ADDENDUM No. 1

RFP No. 22-34

WTP HVAC Improvements – Phase II

M-104

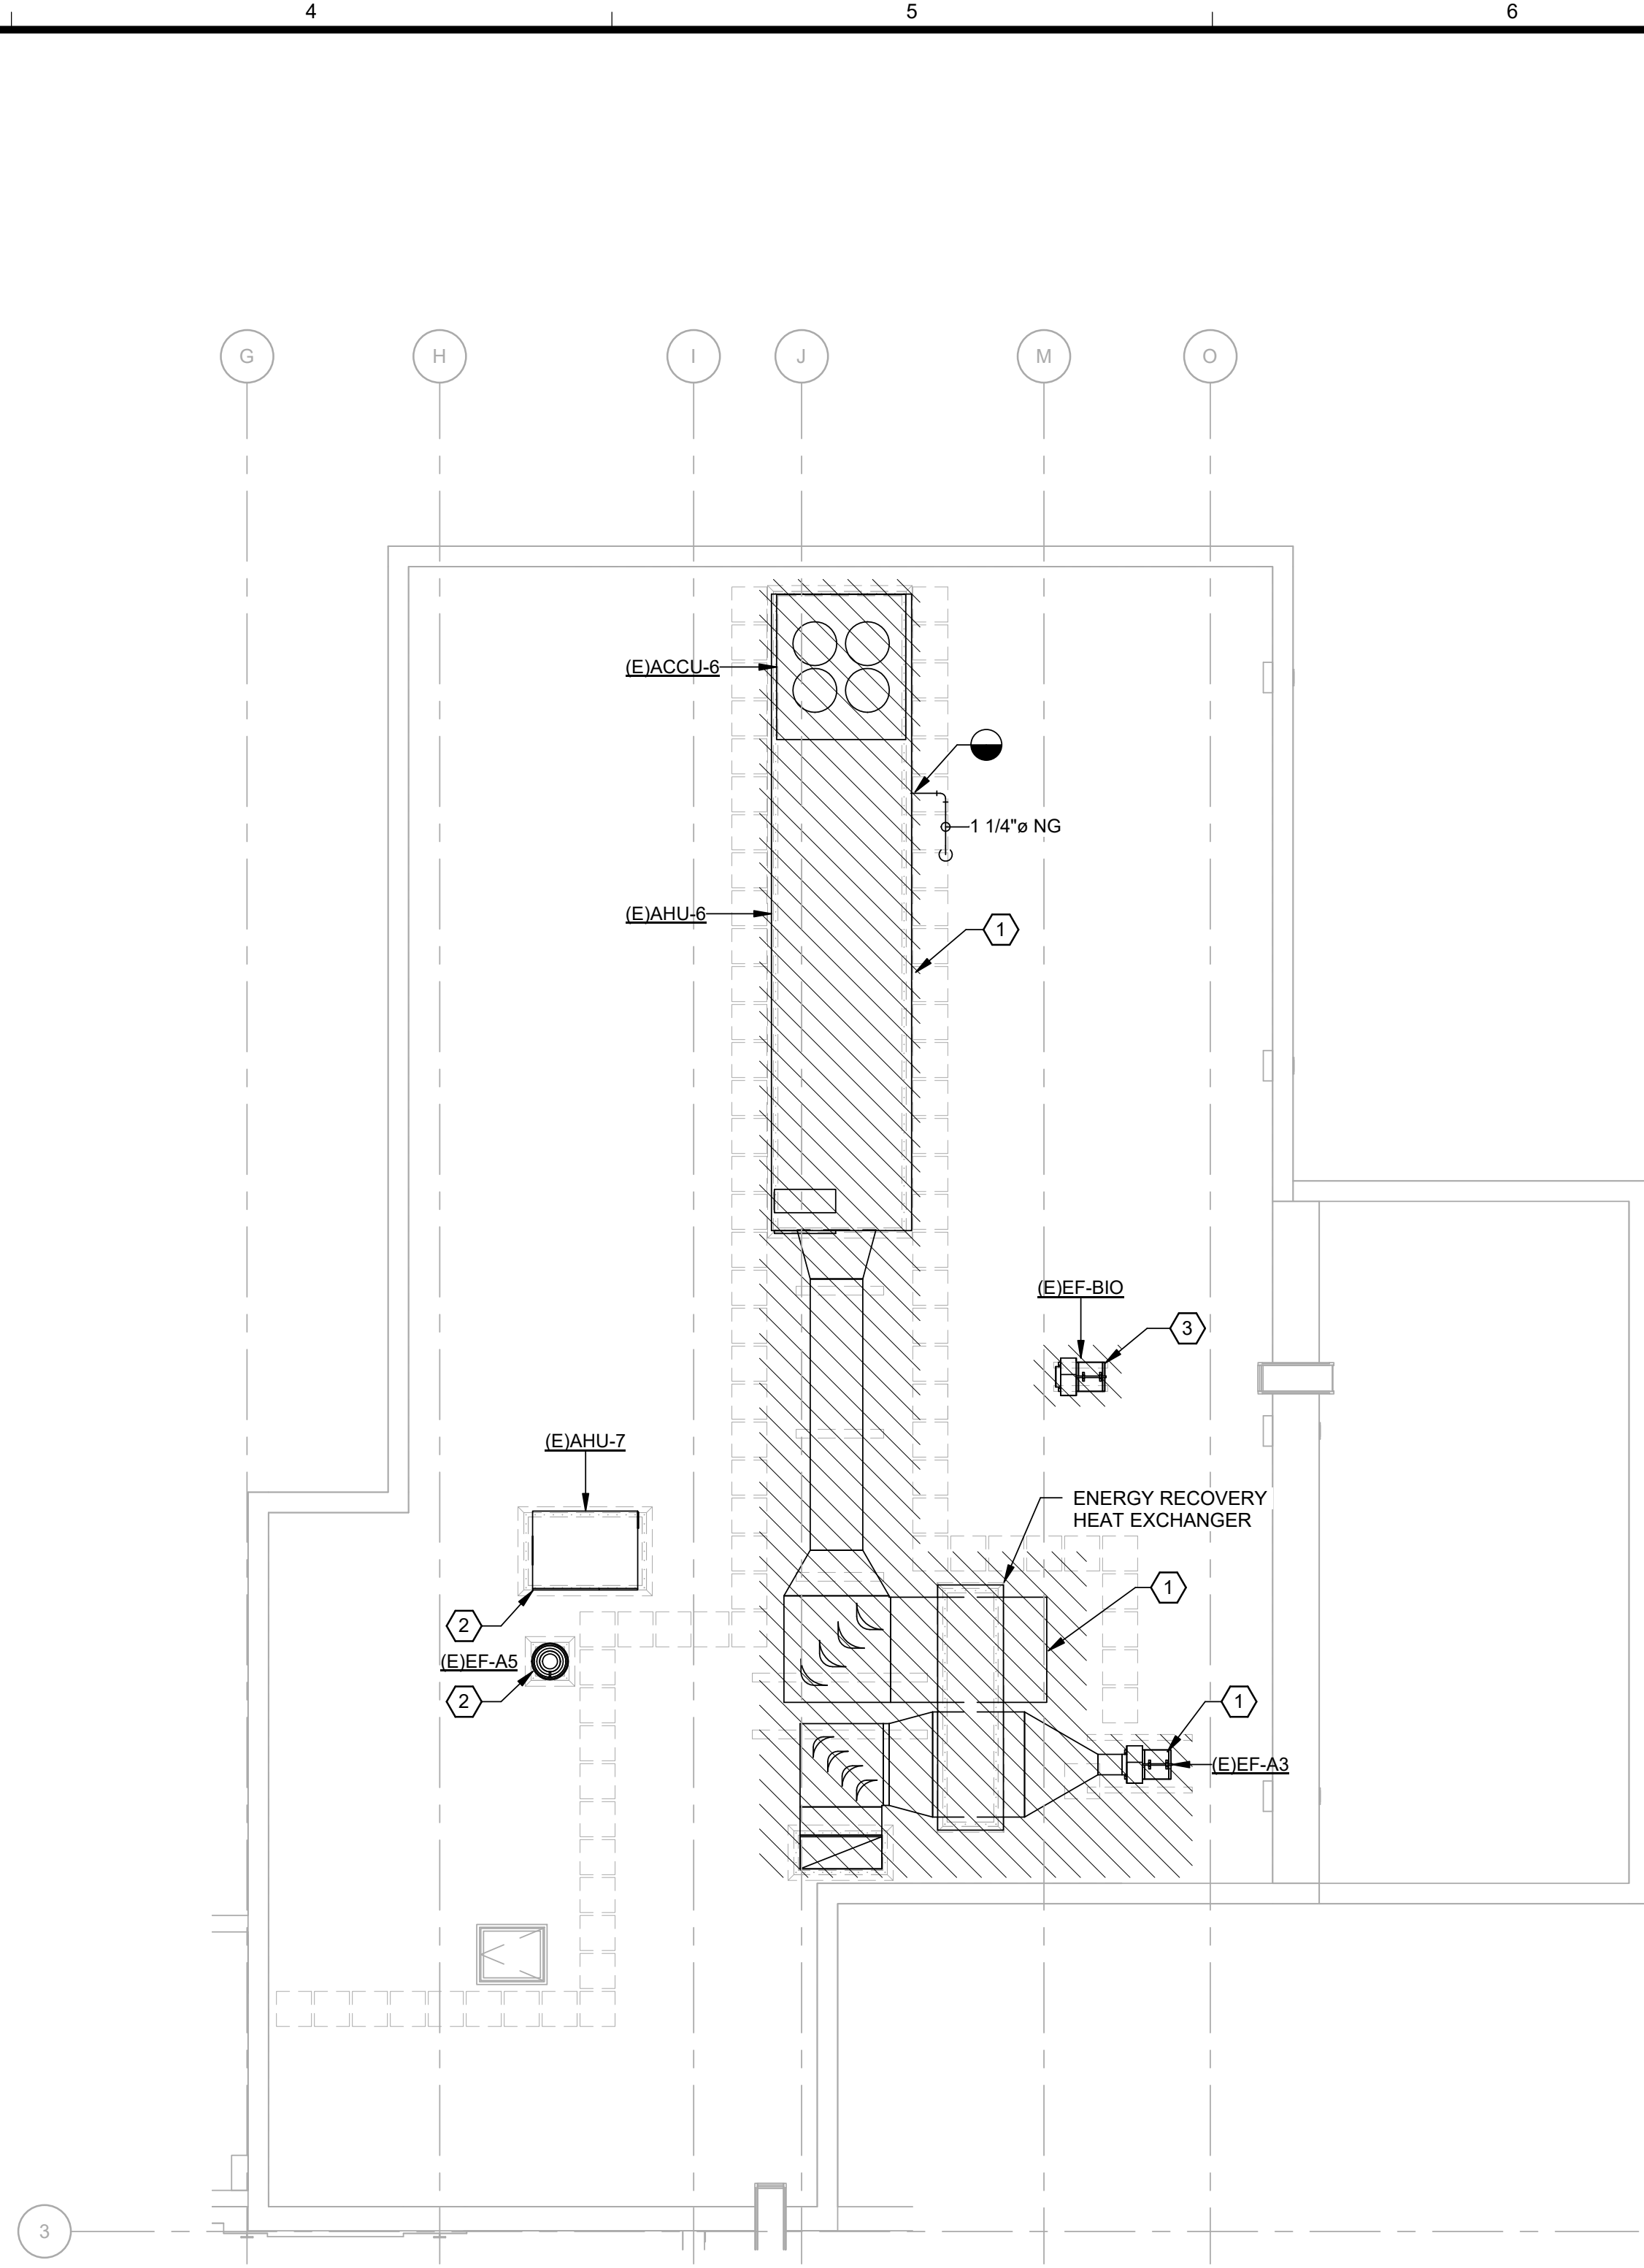
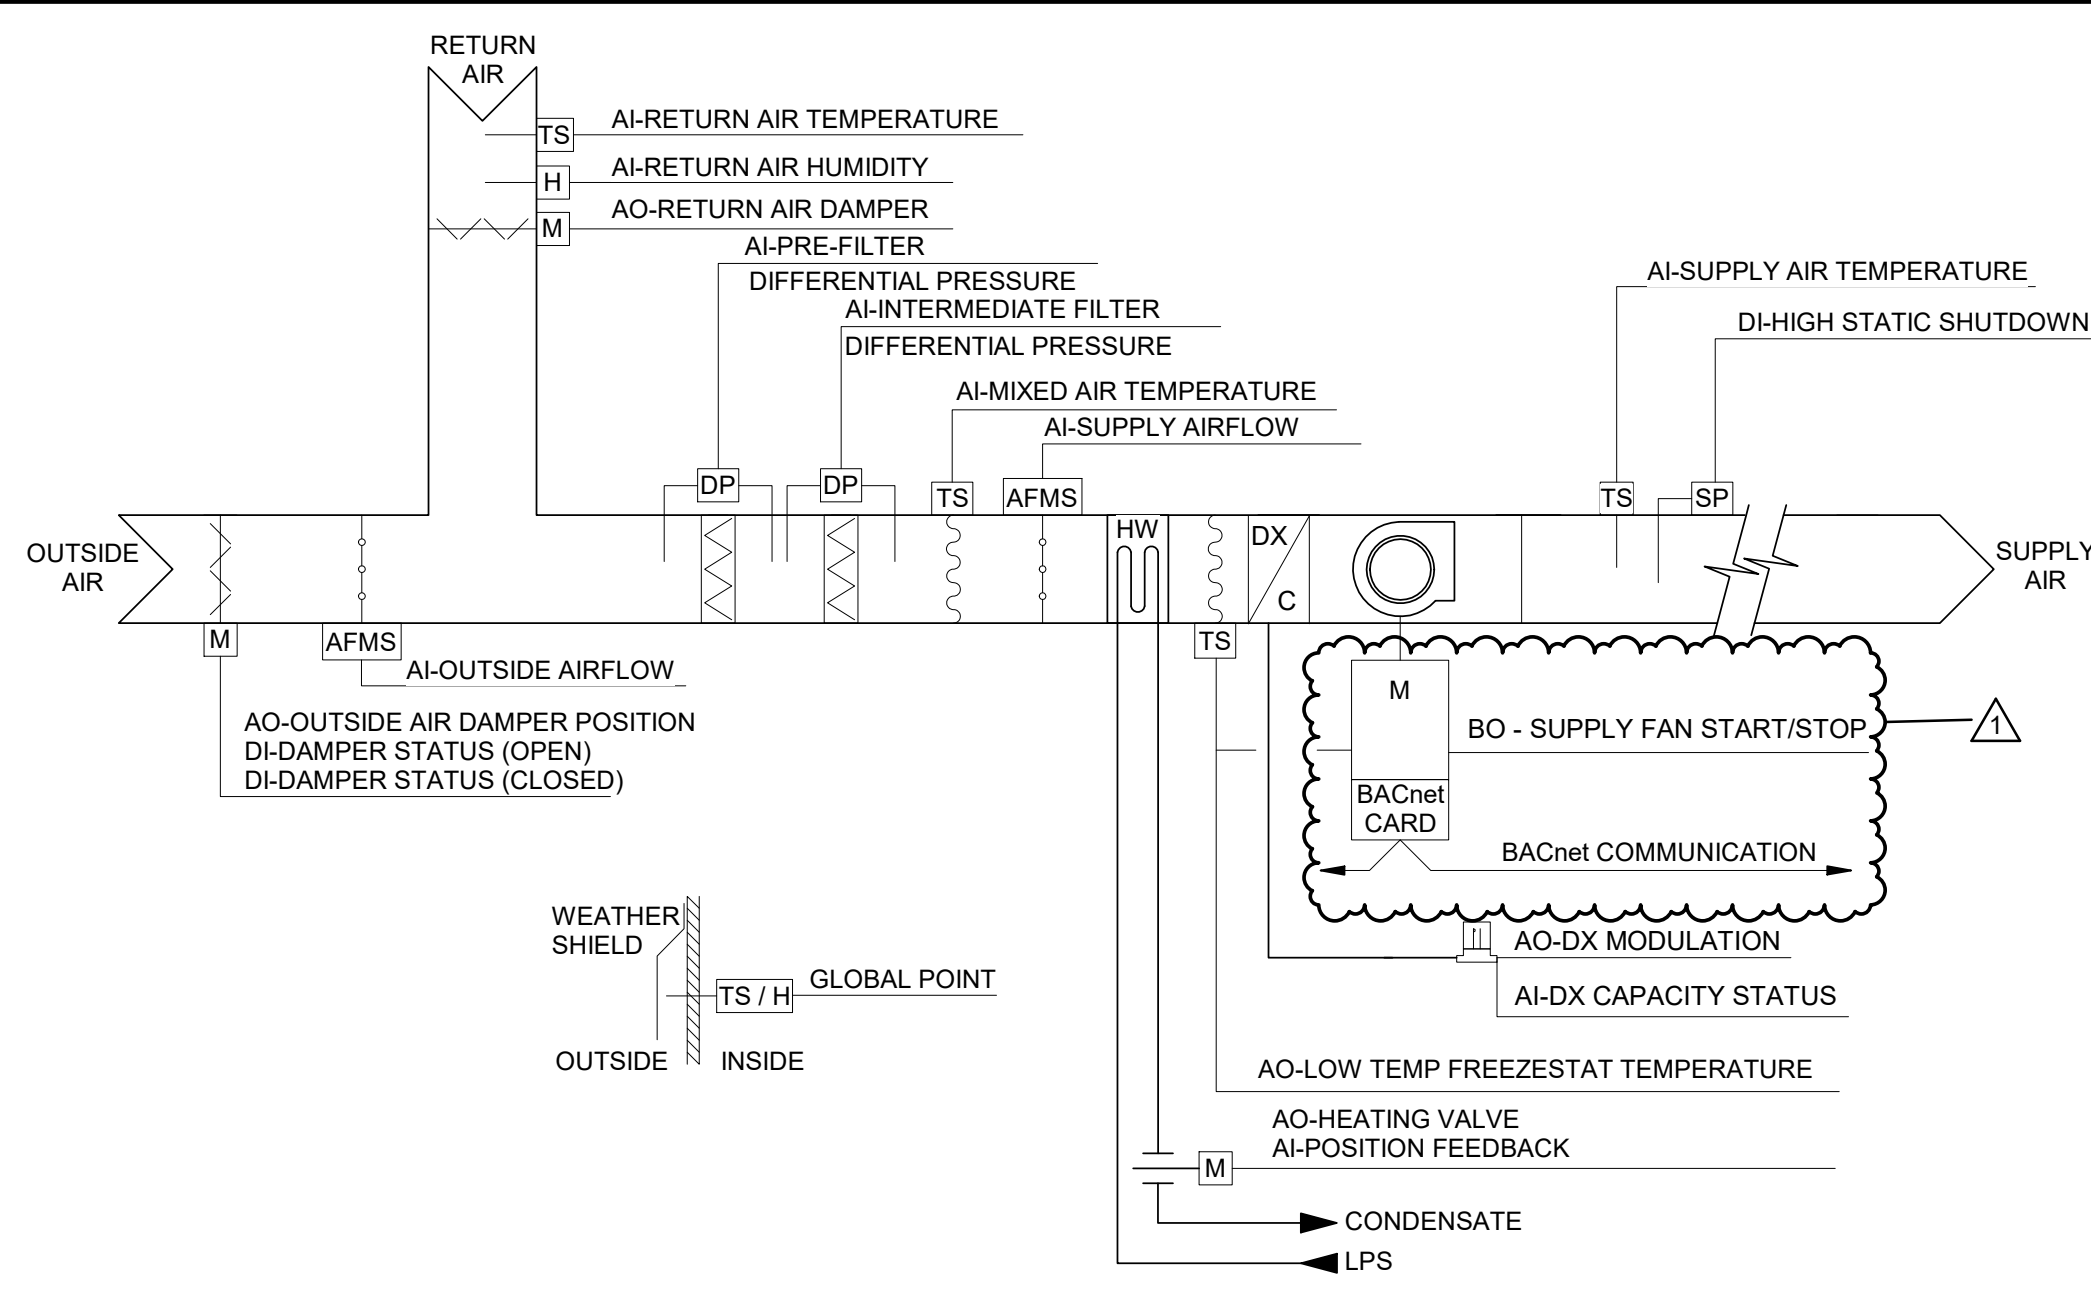
- Question 10: Is a drawing of the duct work required to be demolished for the lab bio-hood, per note 3 on M-104, available?
- Answer 10: M-104 is reissued in Addendum #1.

- 2. AIR HANDLING UNIT AHU-7 AND EXHAUST FAN EF-A5 SERVING BASEMENT LEVEL OF ADMINISTRATION BUILDING ARE TO REMAIN.
- 3. DEMOLISH EXHAUST FAN SERVING BIO-HOOD IN LABORATORY AREA AND ALL ASSOCIATED ACCESSORIES, SUPPORTS, CONTROLS AND WIRING. DEMOLISH DUCTWORK TO BELOW ROOF, PATCH ROOF PENETRATION IN COORDINATION WITH ARCHITECTURAL ROOF WORK.

M-703

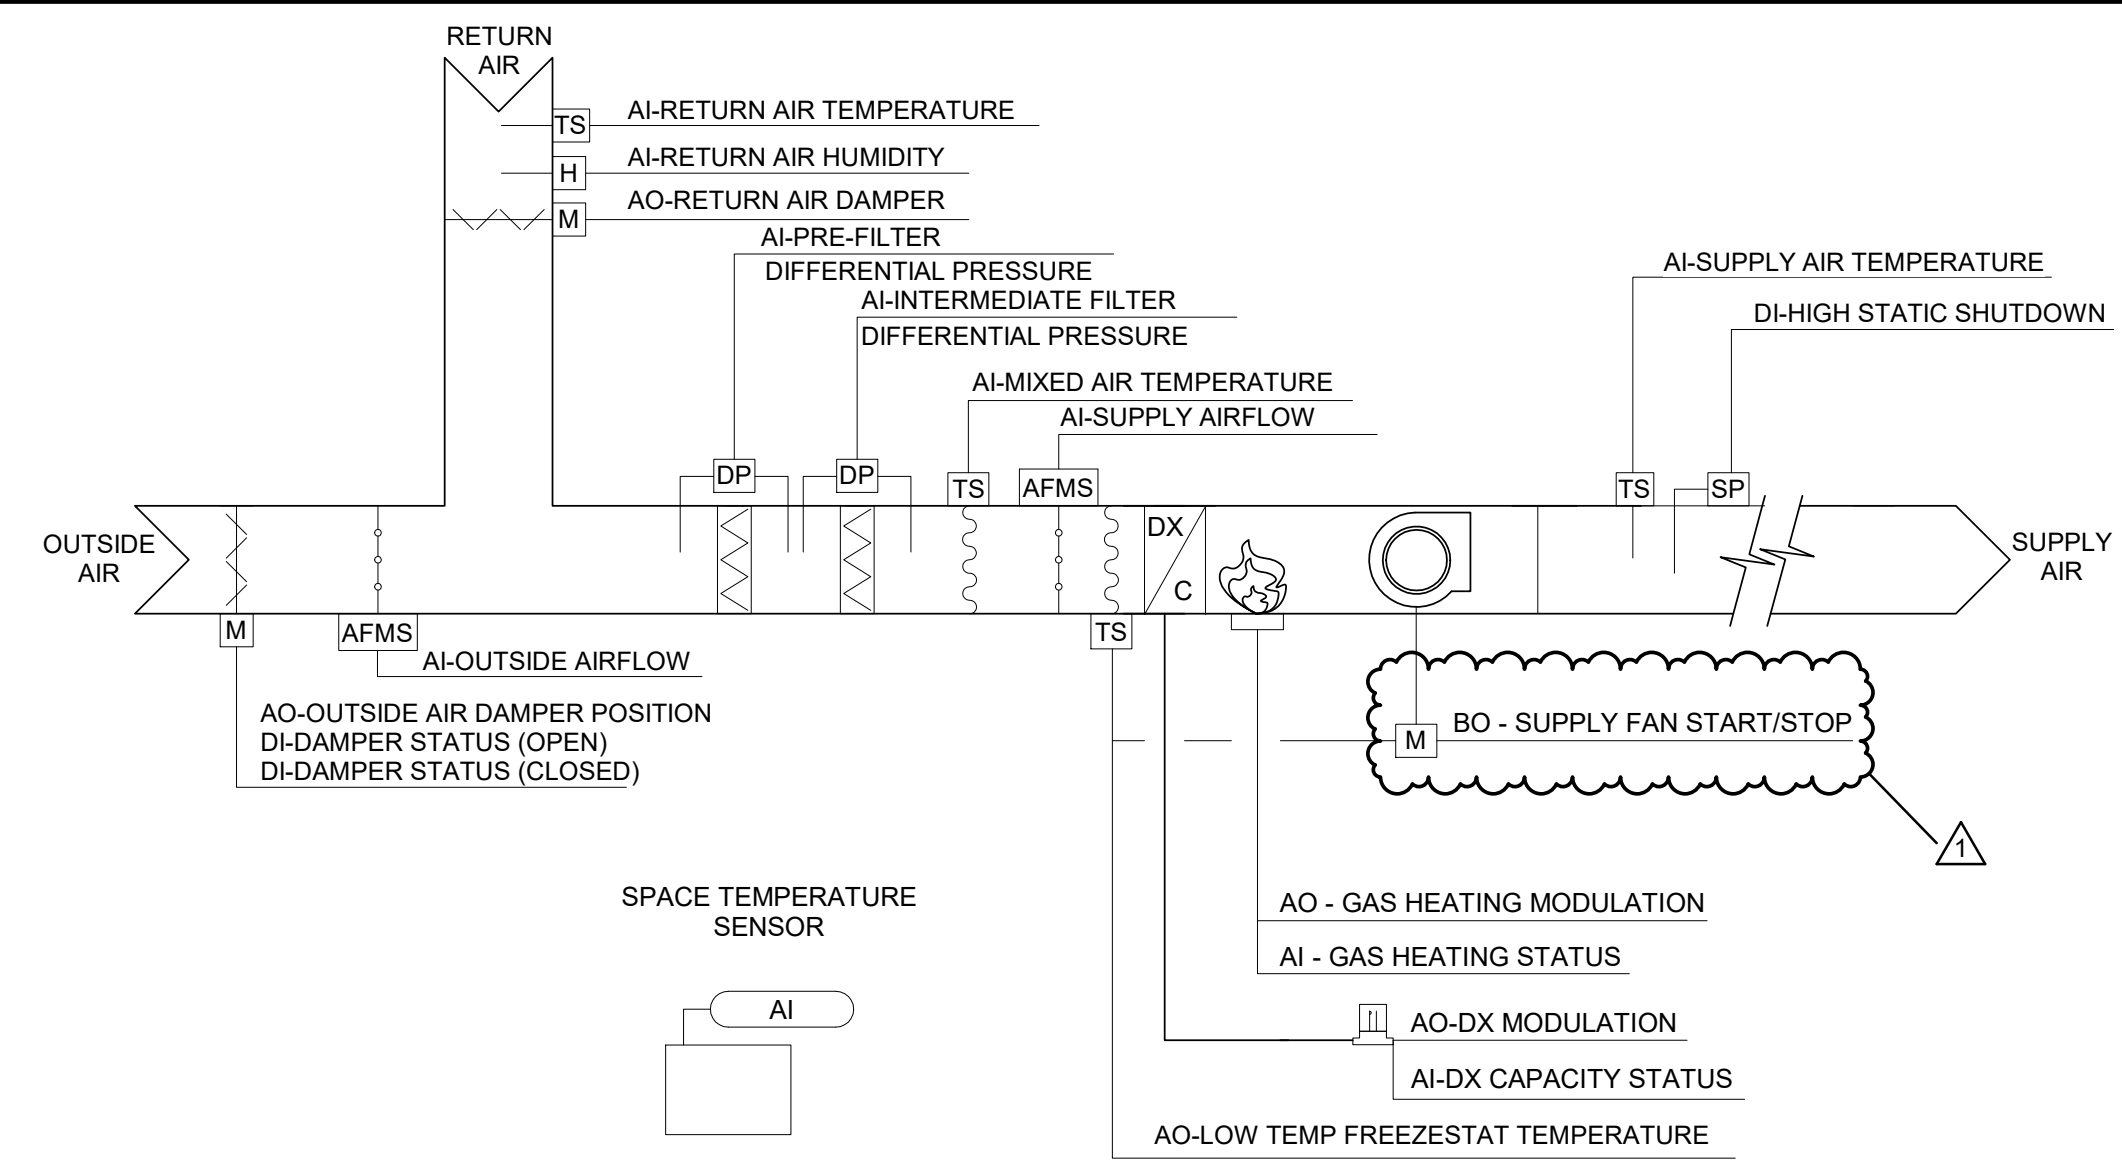
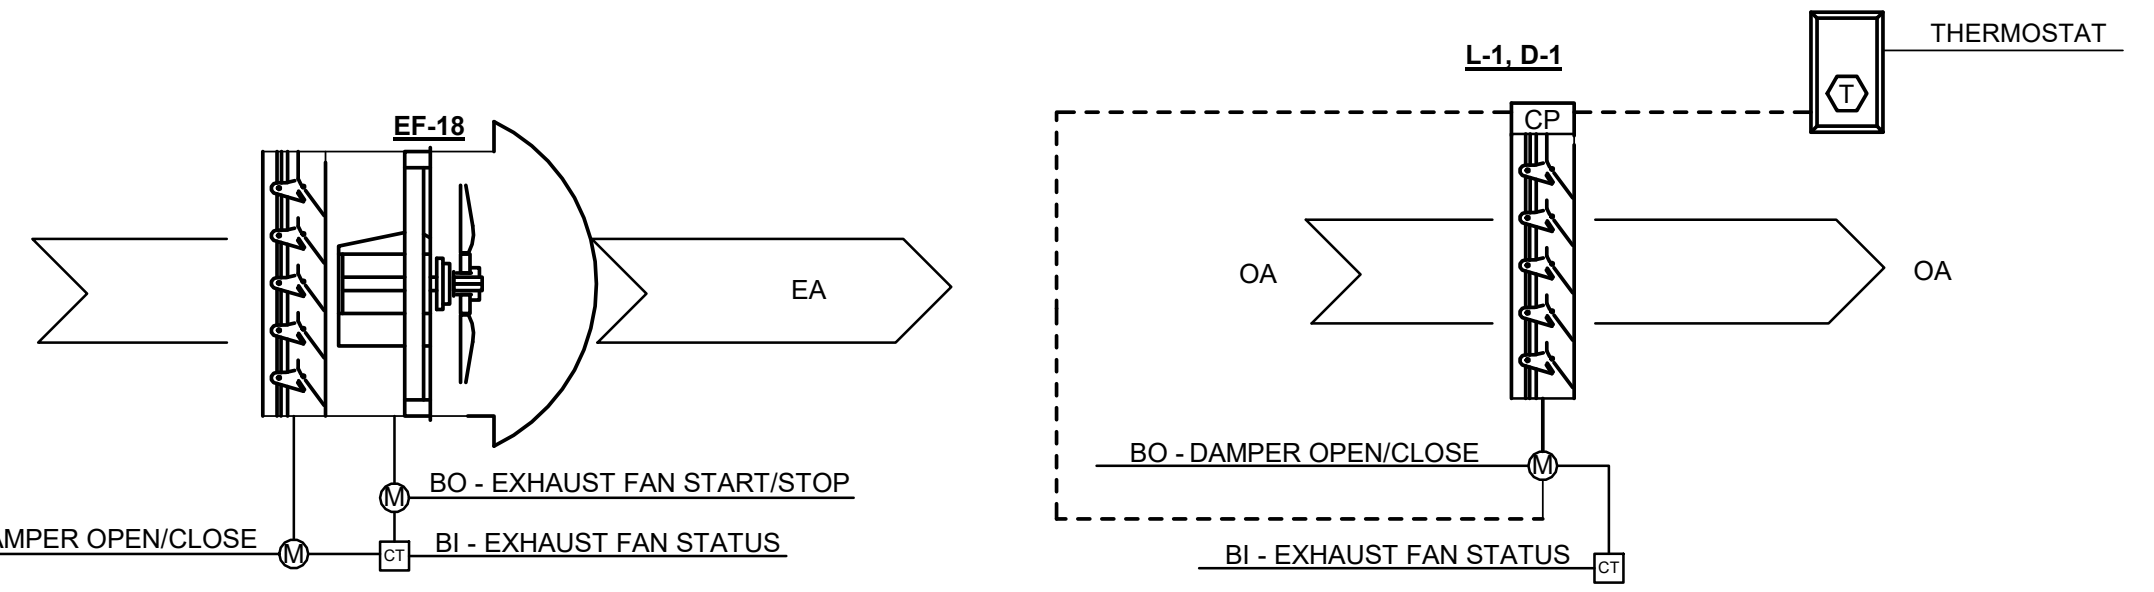
Drawing M-204	On the Chemical Feed Building Fourth Floor/Mezzanine Plan, change Keynote 2 and connection symbol leader lines to point to the east exterior side of the duct chase.
Drawing M-501	Detail 5 removed
Drawing M-701	In Sequence of Operations, change that' "alarms shall be sent to the SCADA system," to, "alarms shall be sent to the plant BMS system."
Drawing M-702	In AHU-1 Controls Diagram and Sequence of Operations, change EF-18 to EF-A4.
Drawing M-703	Reissued
Drawing M-704	Reissued
